FILE NUMBER: Z212-213(LVO)

REQUEST: An application to amend the preservation criteria and exhibits for Historic Overlay District No. 20, the Ambassador Hotel (1312 S. Ervay Street), on property zoned Subdistrict No. 2 within Planned Development District No. 317, the Cedars Special Purpose District.

SUMMARY: The purpose of the request is to amend preservation criteria and exhibits for the Ambassador Hotel Historic Overlay, following destruction of the hotel by fire in 2019.

EXHIBIT C

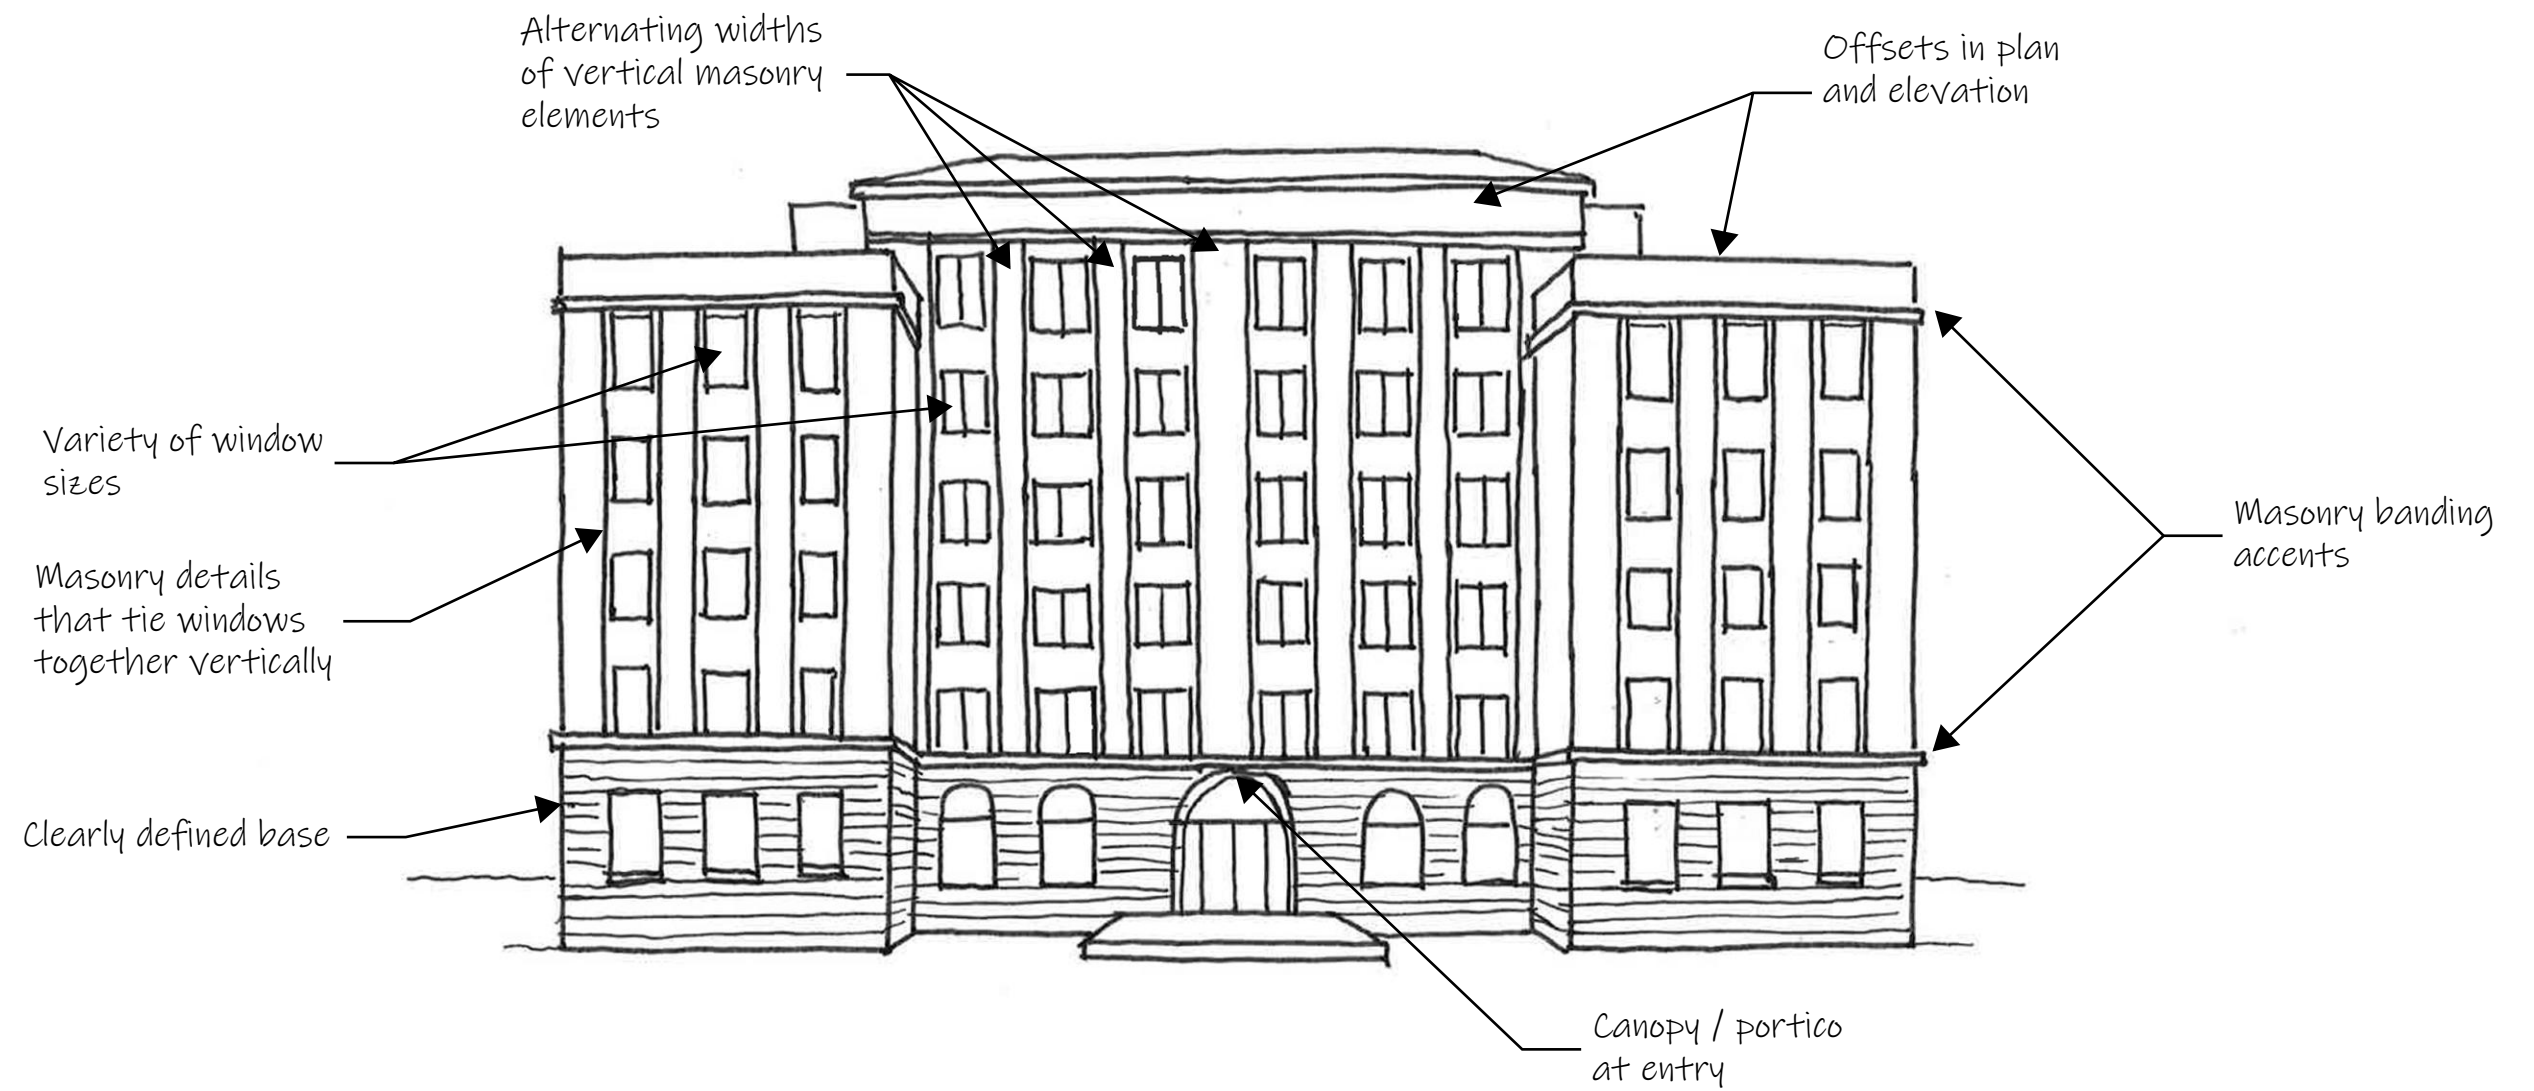
- 1) Revised Exhibit C site plan dated April 28, 2022.
 - 2) Conceptual elevation renamed Exhibit D.
 - 3) Revised Ordinance conditions:
 - Item 1.3(b) – strike “The preservation guidelines for the Original Building are not relevant to the Main Building and do not apply.”

- 1) Revised Exhibit C site plan dated April 28, 2022.
 - 2) Conceptual elevation renamed Exhibit D.
 - 3) Revised Ordinance conditions:
 - Item 1.3 (b) – strike “The preservation guidelines for the Original Building are not relevant to the Main Building and do not apply.”
